Addendum 001

Morgan Hill Butterfield Fire Station

Issued: May 4th, 2023

PROJECT NUMBER: 211224
SHEET TITLE: UTILITY PLAN

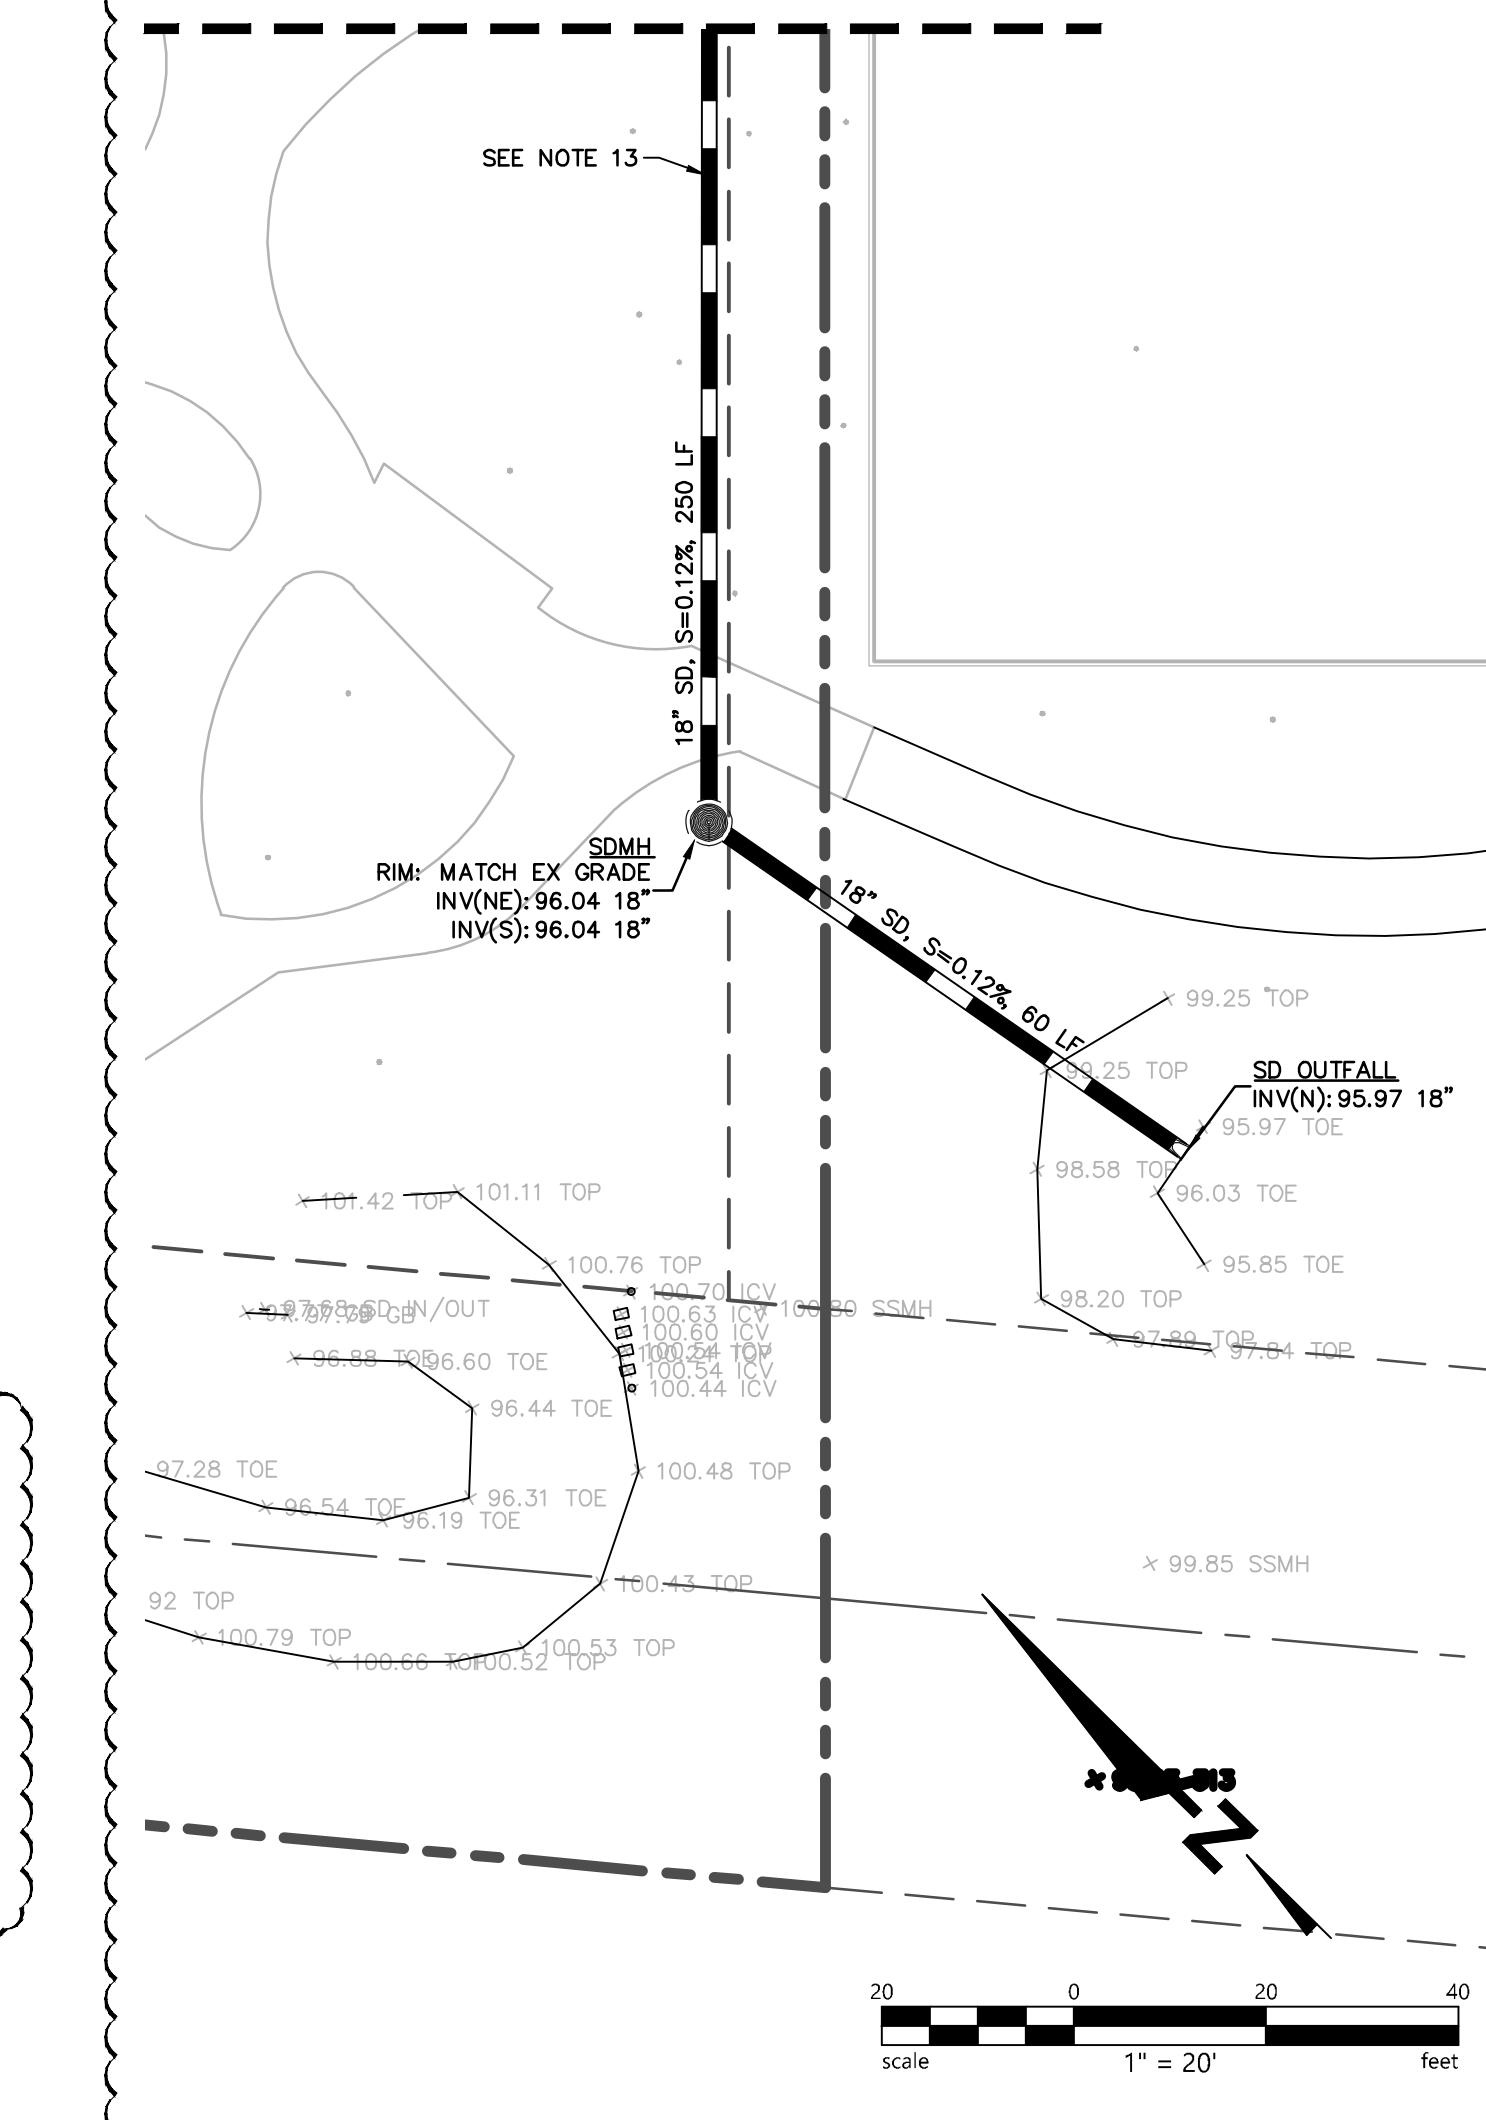
For the new storm drain line shown on C5.0 that heads South and outfalls, please confirm all existing trees/plants along this line are to be removed (not shown on the demo plans, plants/trees are visible on Google Maps).

Storm drain extends past the adjacent parking lot to storm drain outfall, concrete flatwork to be replaced in kind, sheet C5.0 has been updated for scope clarification.

There are 2 RWL shown on the Trash Enclosure A1.2. Drainage plans C5.0 only shows one of them connecting to storm system. Please confirm if there is to be an additional storm line for this RWL.

Disturbed landscape or hardscape outside of fire station campus to be replaced in kind, see disturbed landscaping note on sheet C5.0

Both RWL's are to be connected to underground drainage system, sheet C5.0 has been updated.

DISTURBED LANDSCAPING NOTE:
The contractor should remove and dispose of shrubs and trees that conflict with the new storm drain line, and stockpile the native soil removed for the trench. The removed plants shall be replaced with the trees and shrub/grasses as listed below. Replacement trees and shrubs/grasses shall be installed as close to the original location of the removed plants as possible whilst maintaining a 5'min (measured from center of rootball) clearance from the pipeline. The pipe trench should be backfilled with the stockpiled native soil and covered in 3" of mulch. Disturbed or removed concrete flatwork to be replaced in kind and match original walkway design.

SHEET TITLE:
REFLECTED
CEILING PLAN

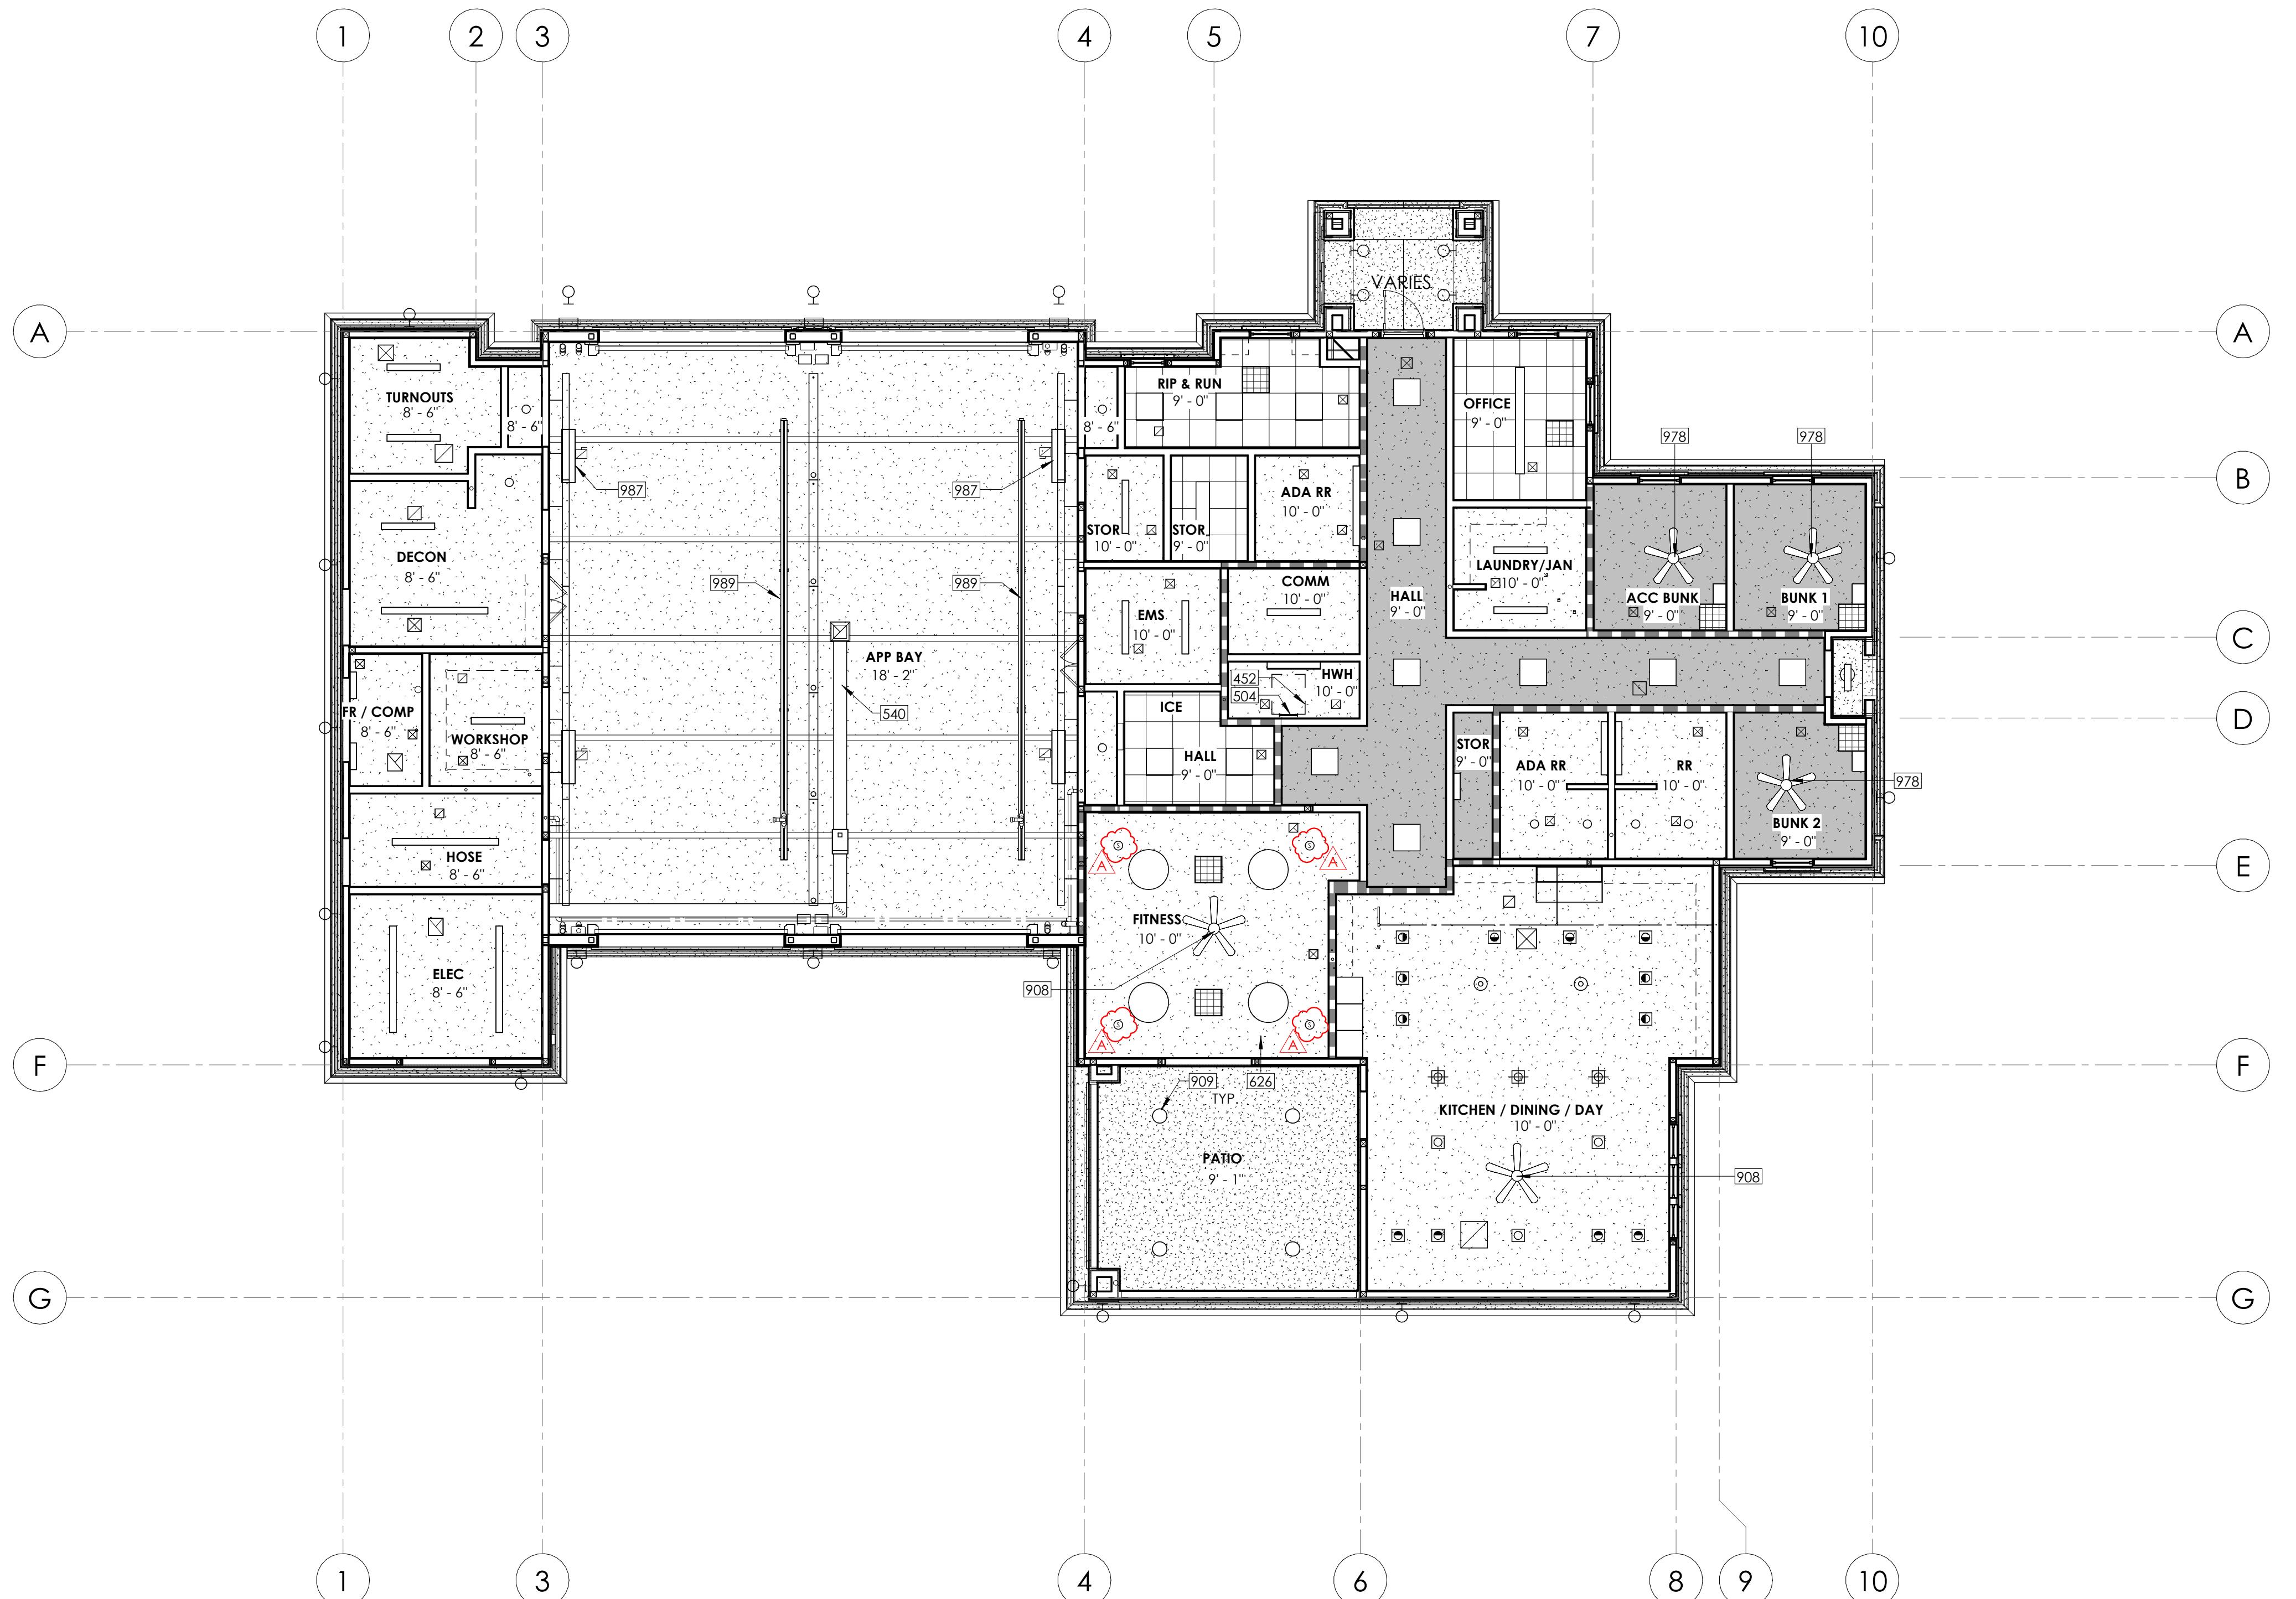
Speakers are located in the fitness room, provide (4) recessed ceiling mounted speakers, RCP has been updated

Ceiling fans are architectural, not mechanical. Ceiling fans in bunk rooms are 44" Kichler with recessed wall mounted controls, BigAss model es6 fans at 60" diameter are to be installed in the Fitness and Dining rooms, see sheet A2.3 and cut sheets for clarification.

D4 ENLARGED ENTRY PLAN
A7.4 SCALE: 1/4" = 1'-0"

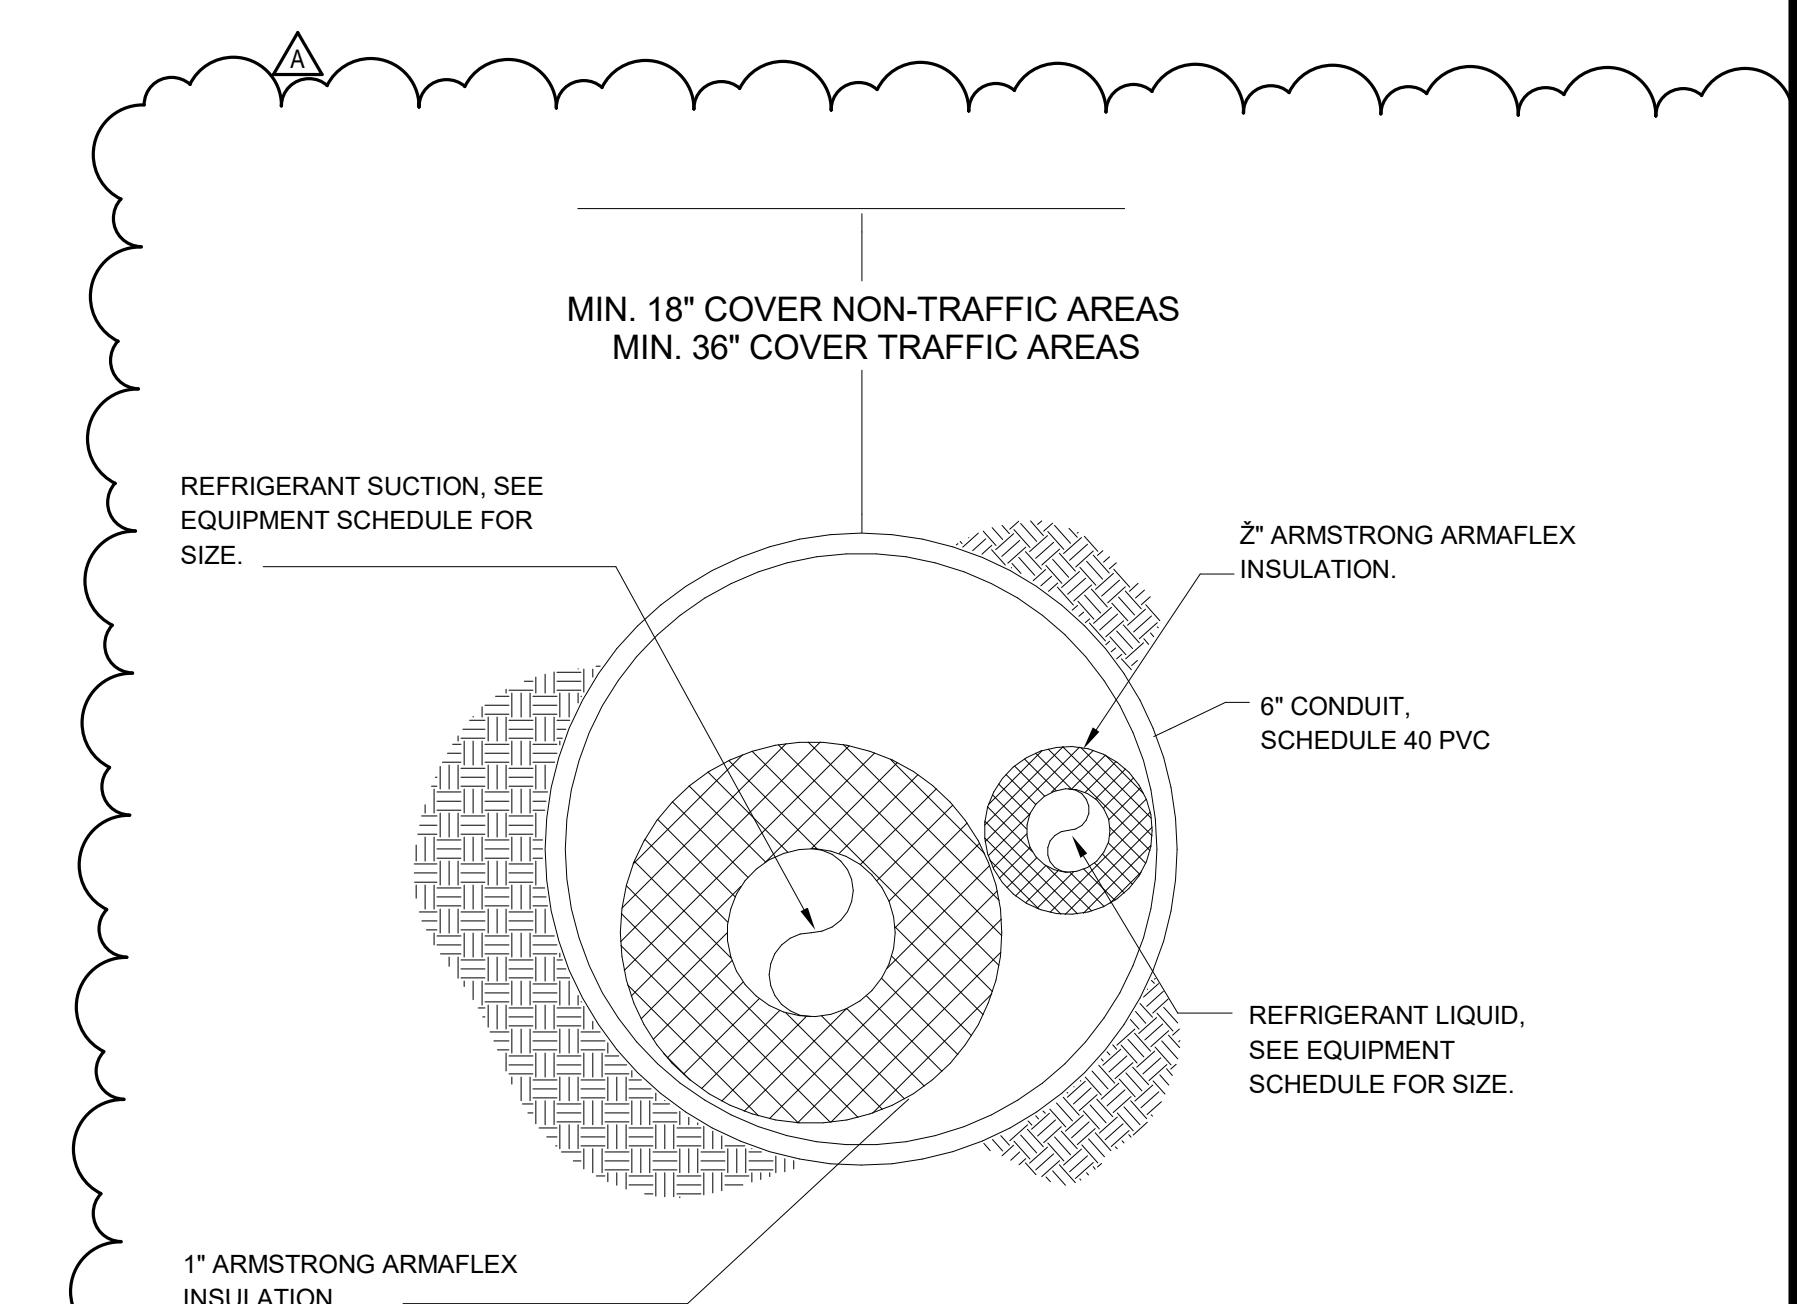
Sheet A3.1 shows brick veneer on exterior at entry archways. Details on A7.4 show stucco only and no brick. Please confirm.

reference detail C4/A7.3 for brick veneer at stucco trim. Install exterior archways with brick veneer with stucco trim finish as shown on elevations, updated detail has been provided.
